Re:	**River North (formerly Liberty Towers)**
CEQR No.	20DCP140R
ULURP No(s).	C 210289 ZMR, N210290 ZRR, C 210291 ZSR, N210281LDR
SEQRA Classification:	Unlisted
Staten Island Community District:	SI01

TECHNICAL MEMORANDUM 001
Potential City Council Modifications
River North (formerly Liberty Towers)
CEQR No. 20DCP140R

ULURP Nos.: C 210289 ZMR, N 210290 ZRR, C 210291 ZSR
29 October 2021

Figure 1: Modified Rezoning Area

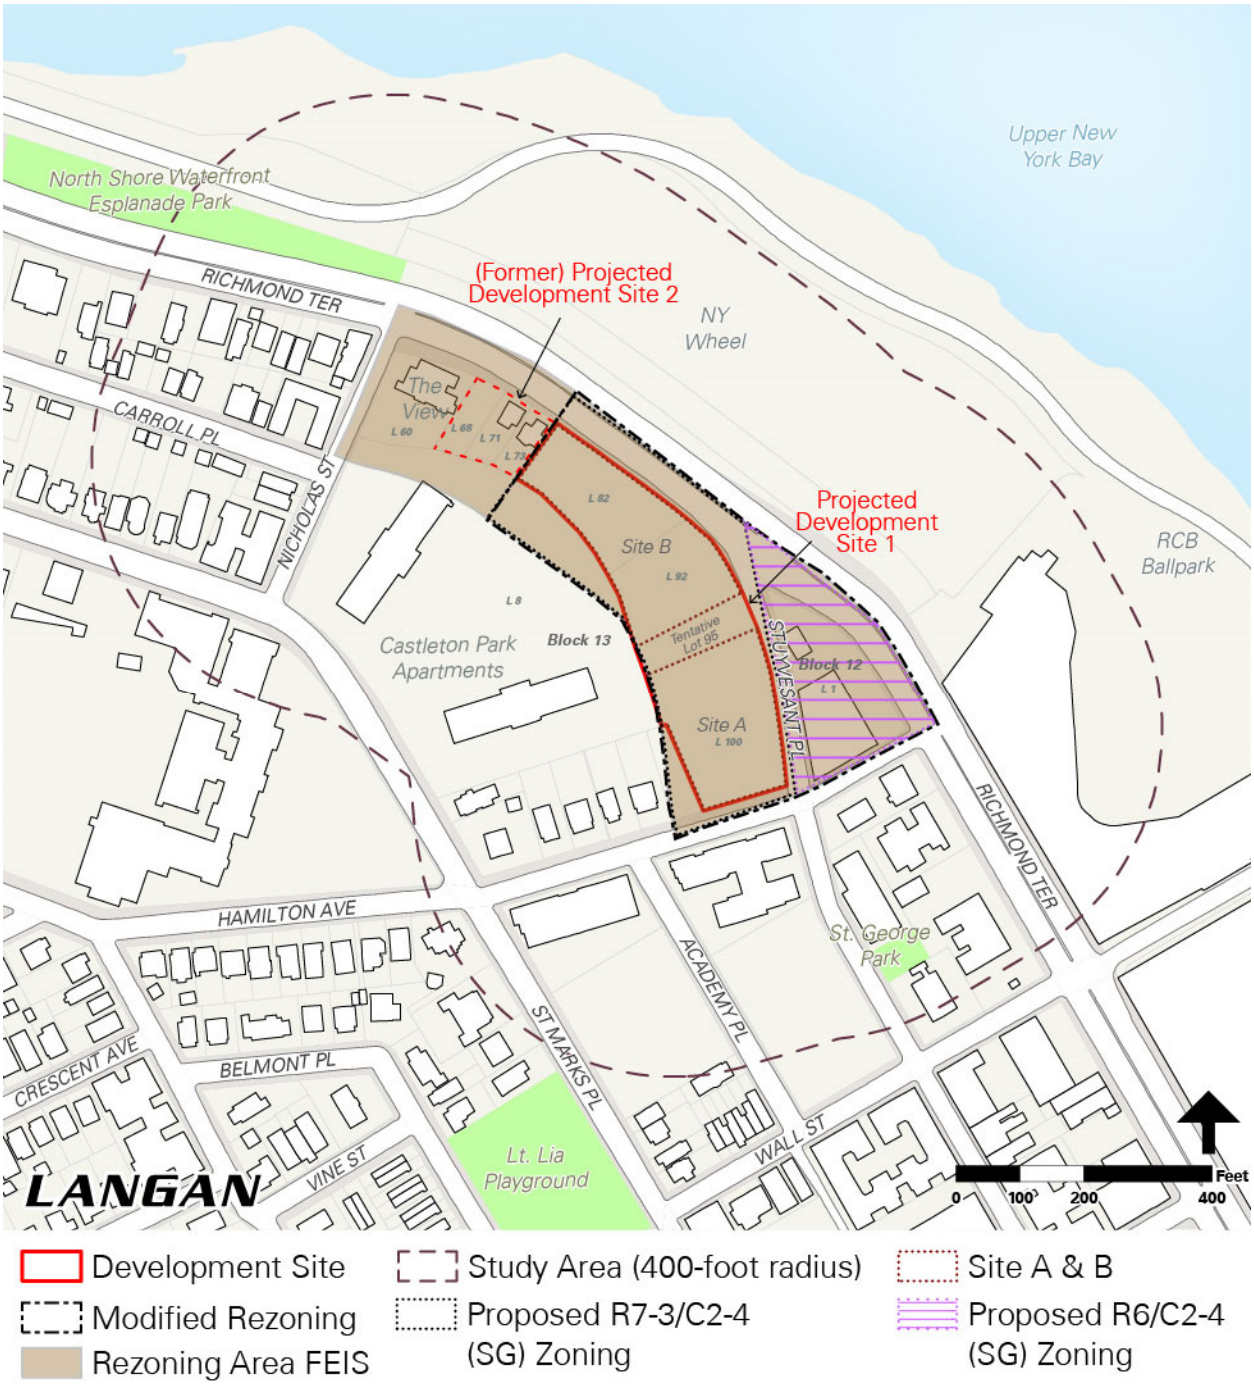
The Modified Actions would remove Projected Development Site 2 from the Rezoning Area and reduce the heights of Buildings 1, 2, and 3 on Projected Development Site 1 to maximum roof heights (top of roof) to 173.03 feet, 104.64 feet, and 132.14 feet, respectively. The height modifications to the buildings on Projected Development Site 1 would result in a reduction of floor area and dwelling units and the reconfiguration of parking facilities.

Figure 1 shows the Modified Rezoning Area, and Table 1 shows the change in programming between the FEIS and the programming that is projected to result from the Modified Actions. The special permit drawings for the Modified Project are provided in Appendix A.

Figure 2: Modified Building Massings

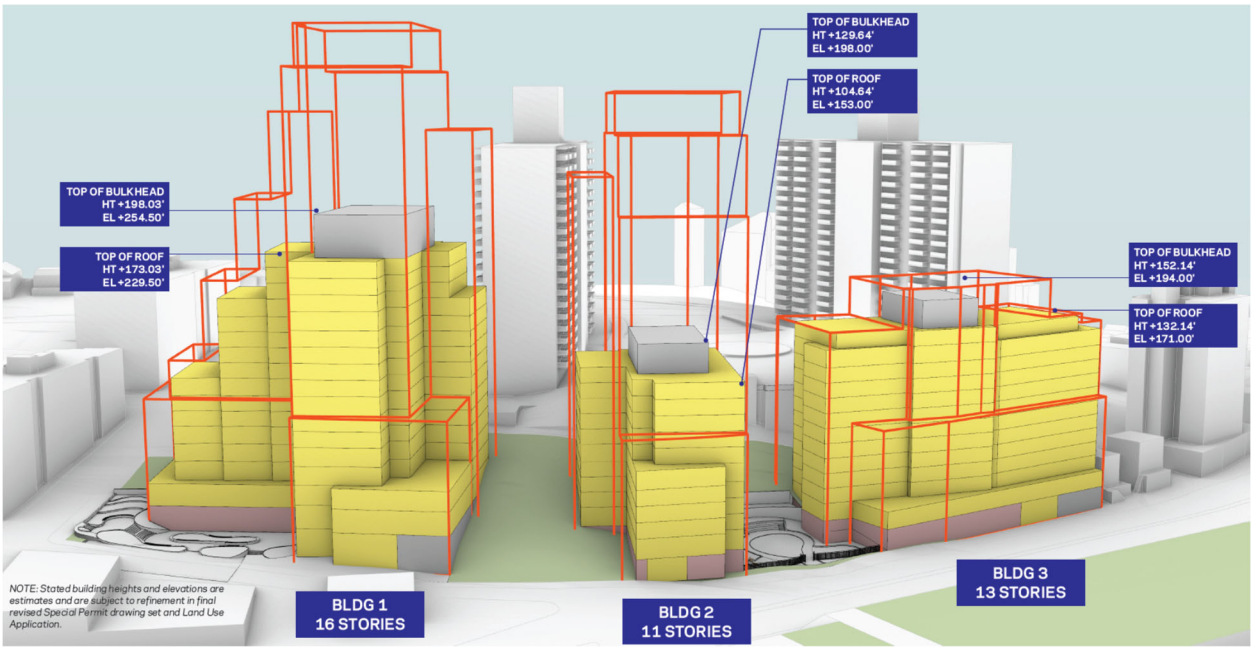
Figure 2 shows the building bulk that would result on Projected Development Site 1 from the Modified Actions; the Modified Project would be wholly within the building envelopes analyzed in the FEIS.

Note: The red lines show the maximum building envelopes analyzed in the FEIS.

Figure 3: HVAC and Hot Water Emissions from Building 1

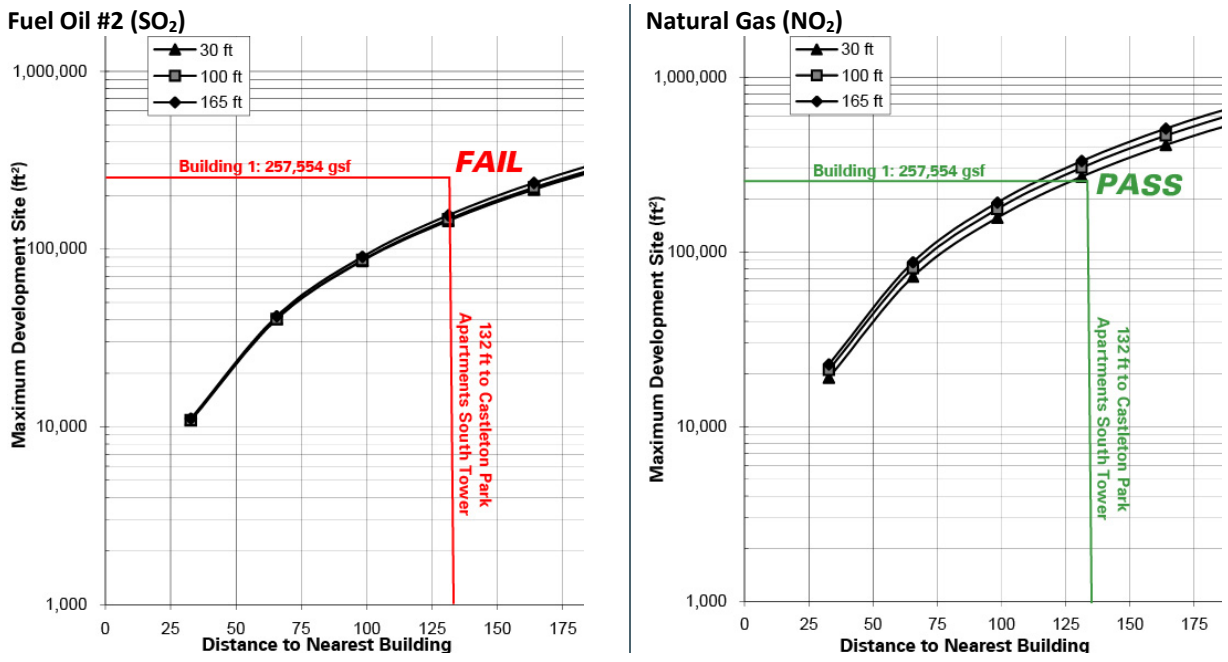
Because Building 1's emissions stack would be at 195 feet above grade and below the elevation of the sensitive receptors at the Castleton Park Apartments South Tower, an HVAC screening was warranted. Building 1 would contain 257,554 gsf of non-parking floor area (the parking area would not be served by the building's HVAC system). The bulkhead would be at least 127 feet from the nearest façade of the Castleton Park Apartments; because Building Code requires the emissions stack be at least 5 feet from the roof edge, the emissions stack on Building 1 will be at least 132 feet from the Castleton Park Apartments South Tower. The HVAC screenings for Building 1 are provided in Figure 3.

Figure 4: HVAC and Hot Water Emissions from Building 2

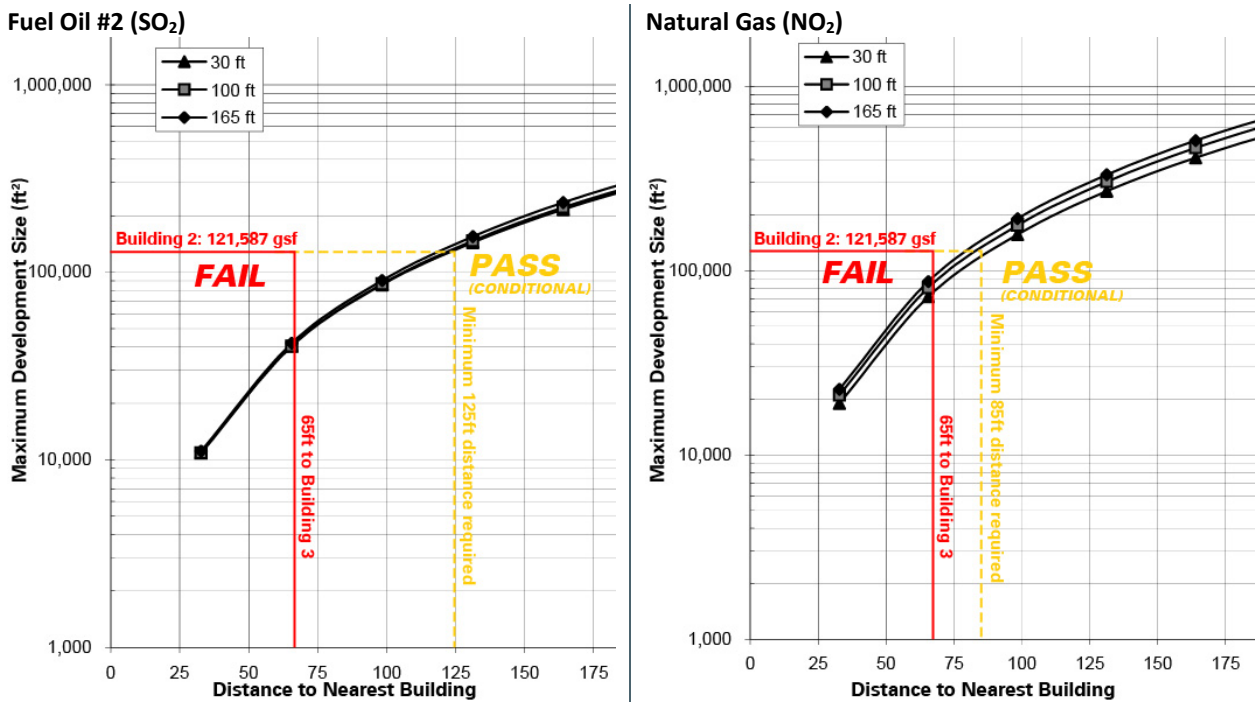
Building 2 would have a bulkhead height of approximately 125 feet in the Modified Project, and an emissions release point of approximately 128 feet. The nearest receptor of similar or greater height to the building's bulkhead would be Building 3 at a minimum distance of 60 feet. When incorporating the 5-foot setback from the roof edge that is required by Building Code, Building 2's emissions stack would be at least 65 feet from Building 3. Building 2 would contain 121,587 gsf of floor area that would be served by the building's HVAC and hot water systems. Building 2's nomographs for both natural gas and fuel oil #2 are shown in Figure 4.

The nomograph shows that Building 2 would fail the screening with the use of fuel oil #2 if the emissions stack is located within 125 feet of a building of similar or greater height, or within 85 feet if natural gas is used. Because of the configuration of the proposed buildings and the location of Building 2's bulkhead, it may not be possible to site the emissions stack more than 125 feet from a receptor of similar or greater height. Portions of Building 2's bulkhead would be at least 85 feet from a receptor of similar or greater height and 5 feet from the bulkhead's edge. Accordingly, an E-Designation would be warranted specifying that the emissions stack on Building 2 be located at the highest tier at least 128 feet above grade and at least 85 feet from a receptor of similar or greater height.

Figure 5: HVAC and Hot Water Emissions from Building 3

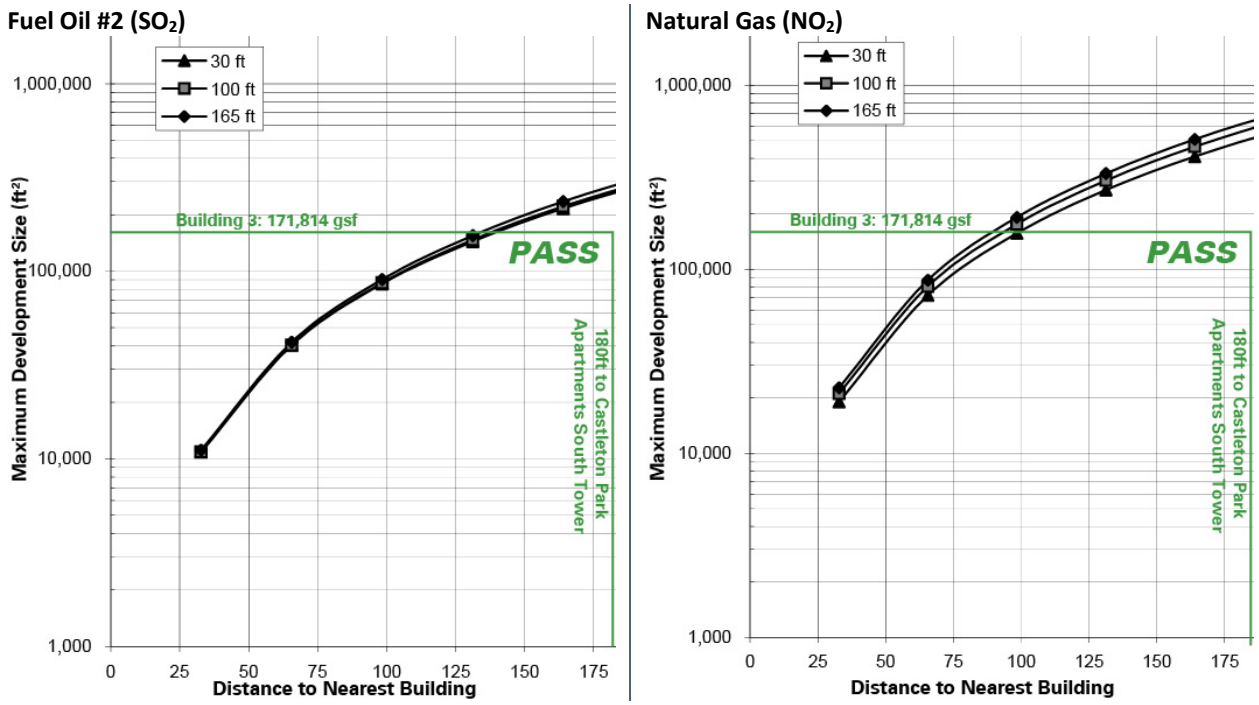
Building 3 would have a bulkhead height of approximately 152 feet in the Modified Project, and an emissions release point of approximately 155 feet. The nearest receptor of similar or greater height to the building's bulkhead would be the Castleton Park Apartments North Tower at a minimum distance of 180 feet, or 185 feet including the required 5-foot setback from the bulkhead's roof edge. Building 3 would contain 171,814 gsf of floor area that would be served by the building's HVAC and hot water systems. Building 3's nomographs for both natural gas and fuel oil #2 are shown in Figure 5.

The nomographs show that Building 3 would pass the screening with the use of either fuel oil #2 or natural gas if the emissions stack is located at the highest tier at least 155 feet above grade. Accordingly, and E-Designation would be warranted for Building 3 specifying that the emissions stack must be located at the highest tier.

Figure 6: HVAC and Hot Water Cumulative Emissions from Buildings 2 and 3

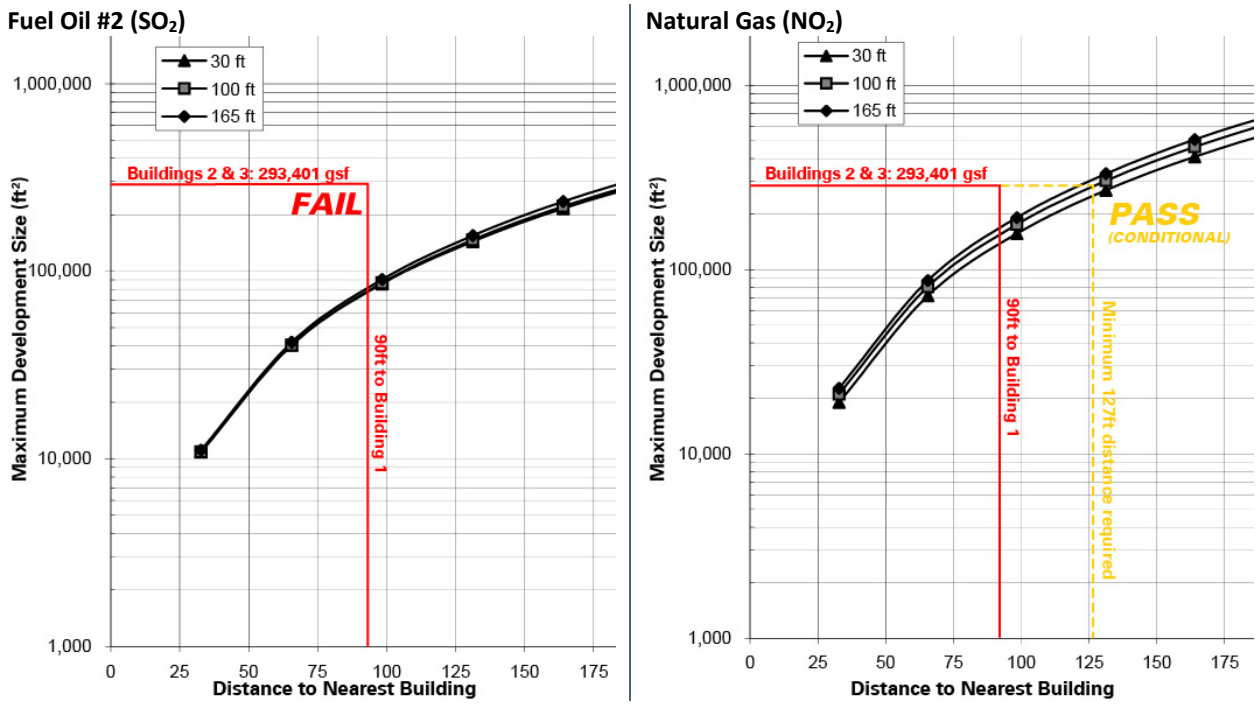
In the Modified Project, Buildings 2 and 3 would be of similar height and have the potential to result in cumulative emissions at nearby receptors of similar or greater height. Combined, Buildings 2 and 3 would contain 293,401 of floor area that would be served by the buildings' HVAC and hot water systems. The nearest receptor of similar or greater height to either Building 2 or 3 would be Building 1 at a minimum distance of 60 feet from Building 2; however, as currently contemplated, Building 2's bulkhead would be at least 90 feet from Building 1 at the emissions height. The nomograph showing the cumulative emissions from Buildings 2 and 3 on Building 1 are shown in Figure 6.

The nomograph of cumulative emissions from natural gas-powered systems in Buildings 2 and 3 show that the emissions stack on Building 2 must be sited at least 127 feet from Building 1 at the emissions height. Accordingly, an E-Designation is warranted for Building 2 specifying that the emissions stack be located at the highest tier and at least 127 feet from Building 1. Because Building 2 also warrants an E-Designation specifying the stack must be at the highest tier and at least 85 feet from Building 3, to account for cumulative emissions, an E-Designation is warranted specifying that:

- HVAC and hot water systems must use natural gas as a fuel source;
- the emissions stack on Building 2 must be located at the highest tier; and
- the emissions stack be located at least 85 feet from Building 3 and at least 127 feet from Building 1.
